**TECHNICAL COMMENTS**  
**on the**  
**ROSIA MONTANA FEASIBILITY STUDY**  
**and the**  
**ROSIA MONTANA PROJECT DESCRIPTION**

David M. Chambers

January 13, 2003

*Locations of Abrud and the proposed Tailings Impoundment (approximately 2 km away)*

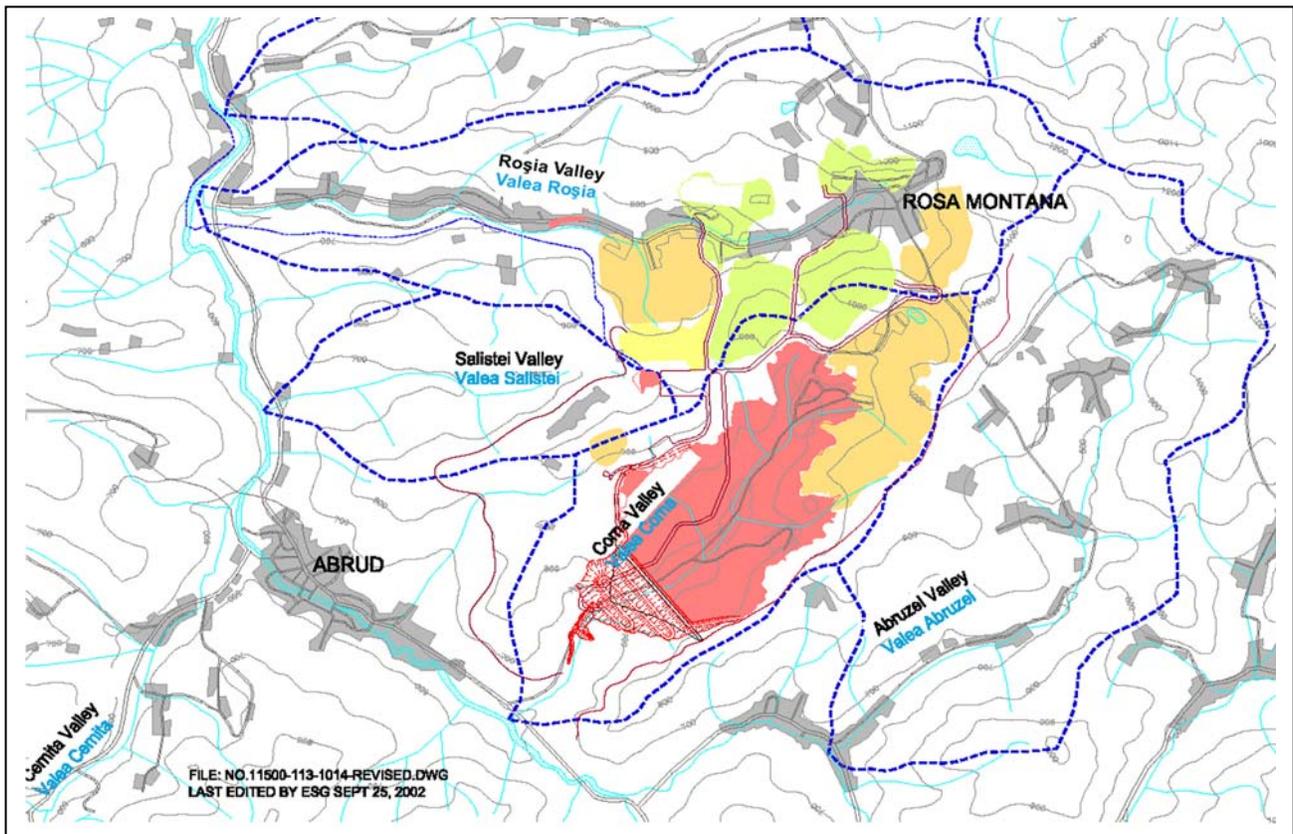
This dam is located approximately 2 km upstream from the town of Abrud (see below). A major or catastrophic failure of the dam could result in significant loss of property and possible loss of life. In most political jurisdictions, if a tailings dam is to be located above inhabited areas, then the dam

*Proposed Rosia Montana Tailings Dam. Lower portion (Stage 1) is centerline-type construction, and Stages 2 – 9 with modified upstream-type construction.*

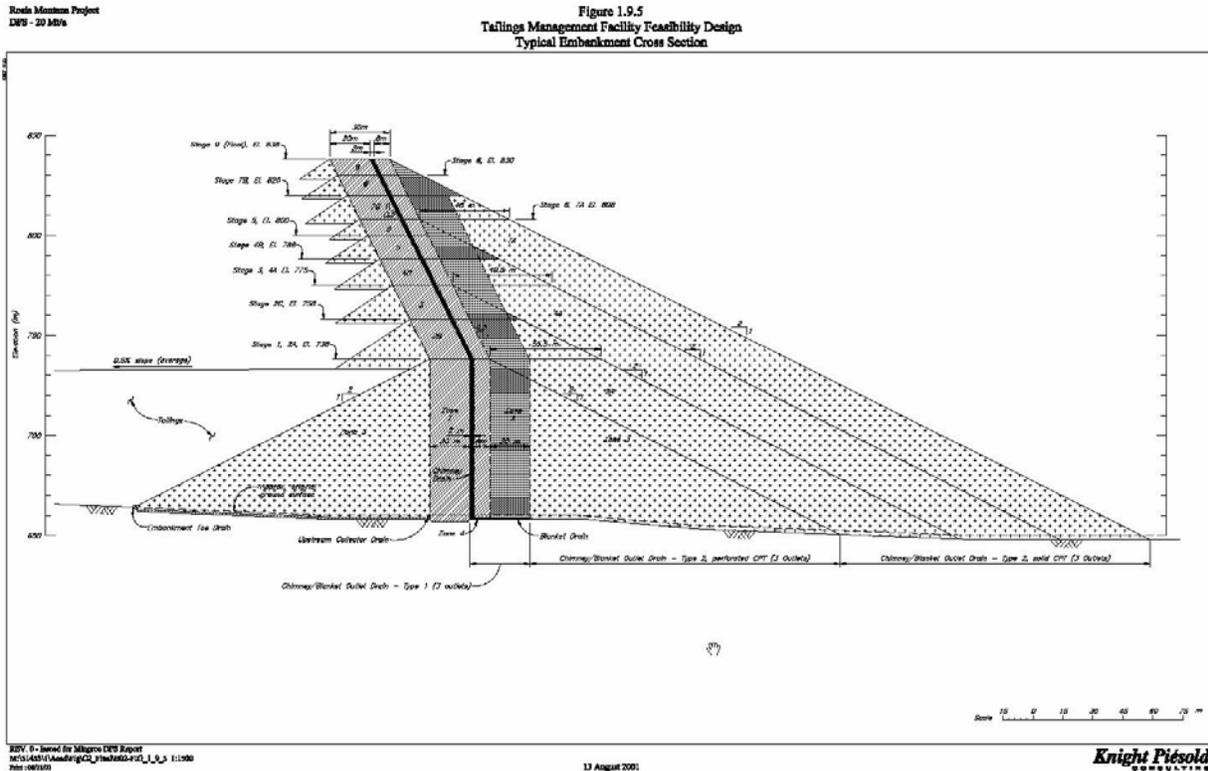
The safest dam design would be to make the entire dam a centerline-type construction. From an engineering standpoint construction of a full centerline dam should be simple to accomplish, but would add to the construction cost of the dam.

Stage 1 is already a centerline design, and Stages 2 – 9 are the modified upstream-type construction, which is essentially half a centerline design, plus some additional material on the upstream side of half-centerline structure.<sup>11</sup> (See a diagram of the proposed Tailings Dam on the next page.) In order to provide an estimate the costs of constructing a centerline dam, instead of the proposed hybrid centerline (Stage 1) / modified upstream (Stages 2 – 9) dam,<sup>12</sup> it is assumed the cost of building Stages 2 – 9 in a centerline configuration will be double the costs estimated in the Feasibility Study for the upstream-type construction.

Assuming a doubling of the construction cost for Stages 2 – 9 is actually overly conservative, since the costs for the dam's impermeable zone and blanket drain, the most expensive parts of the dam to construct, are already accounted for in the present costs. Also, if the dam were constructed as a centerline structure, it would be constructed all at one time, saving the mobilization costs that have been built into the present cost estimate.

The present cost estimate for construction of Stages 2 – 9 is approximately \$30.6 million.<sup>13</sup> Doubling this cost would increase the total cost for dam construction from \$46 million to \$76.6 million. Again, the actual capital outlay should be less given the cost saving factors mentioned above.
